WATTS BAR NUCLEAR PLANT (WBN) UNIT 1 - REQUEST FOR ADDITIONAL INFORMATION (RAI) REGARDING WATTS BAR NUCLEAR PLANT TRITIUM PRODUCING BURNABLE POISON ROD LEAD TEST ASSEMBLIES (TAC NO. M98615)

WATTS BAR NUCLEAR PLANT UNIT 1
RESPONSE TO REQUEST FOR ADDITIONAL INFORMATION
TRITIUM PRODUCING BURNABLE POISON ROD LEAD TEST ASSEMBLIES

Figure 1: Comparison of TPBAR and WABA Worths
for Watts Bar Cycle 2 Lead Test Assemblies

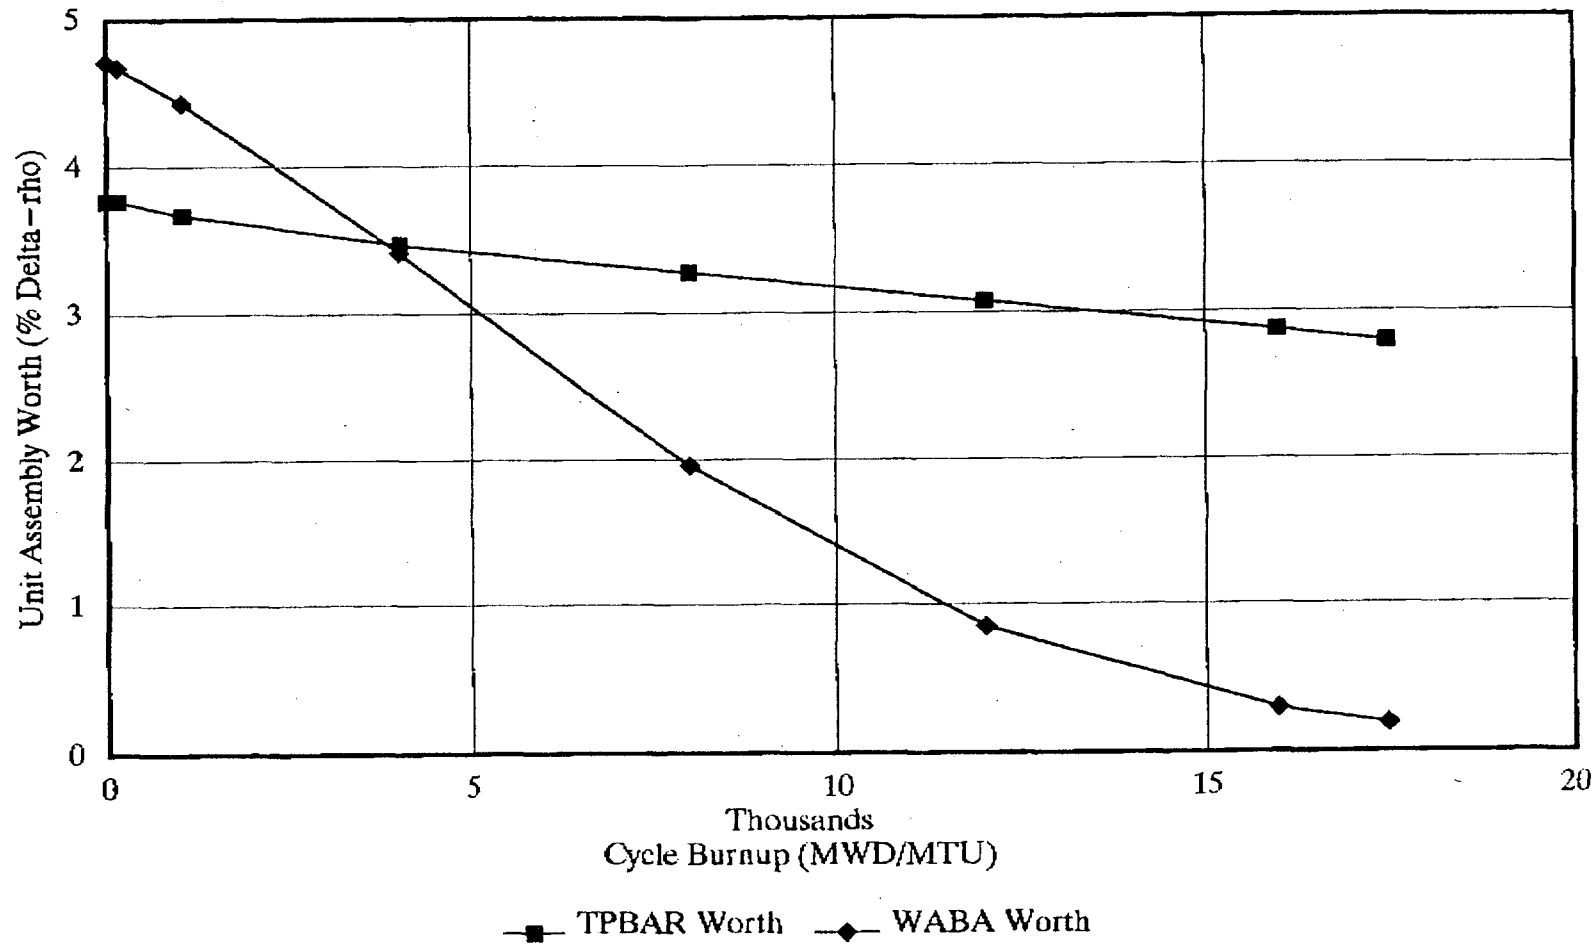
Section 3 of the DOE report does not contain a comparison of the reactivity characteristics of the TPBARs with the burnable poison rod assemblies (BPRAs). Instead, a comparison of the infinite medium multiplication factor (k_{∞}) for TPBARs and wet annular burnable absorbers (WABAs) as a function of burnup is shown in Figure 3-1 of the DOE report. In this case, the close comparison between these two designs is a general indication that other core design parameters are also similar. This analysis illustrates that differences are small enough to be accommodated within the range of core-to-core variations that are customarily handled in fuel cycle design. However, the scoping analysis does not present a basis for ensuring that all core design limits are satisfied. The staff concludes that the Watts Bar license amendment request must contain a comparison of the reactivity characteristics of the TPBAR to the BPRAs in order to demonstrate that the TPBARs are functionally similar to the BPRAs.

To provide a more consistent comparison of TPBAR and WABA worths, a Watts Bar Cycle 2 core model was developed which employed clusters of 8 WABAs in the LTA locations. For the worth comparison, these core models were taken to hot zero power at various points in the cycle depletion to eliminate Doppler feedback. For each of the models (i.e., the model with 8 TPBARs and the model with 8 WABAs), restarts were performed in which the absorber number density, ^{10}B in the case of WABAs and ^6Li in the case of TPBARs, was set to zero. The change in the k_{∞} of the LTA assembly that results when the absorber is removed represents the worth of the absorber in the LTA location. Figure 1 provides these results.

Note in Figure 1 that in the early part of the cycle, the TPBAR and WABA worths are reasonably comparable. This occurs despite the lower absorption cross section of ^6Li relative to ^{10}B , since the loading of ^6Li in the TPBAR is much larger than the loading of ^{10}B in a WABA. The low absorption cross section and high loading of ^6Li , however, combine to cause the TPBAR to retain a substantial fraction of its initial worth even at the end of the cycle. WABAs, on the other hand, lose almost all of their worth since, by end-of-life, nearly all the ^{10}B is depleted.
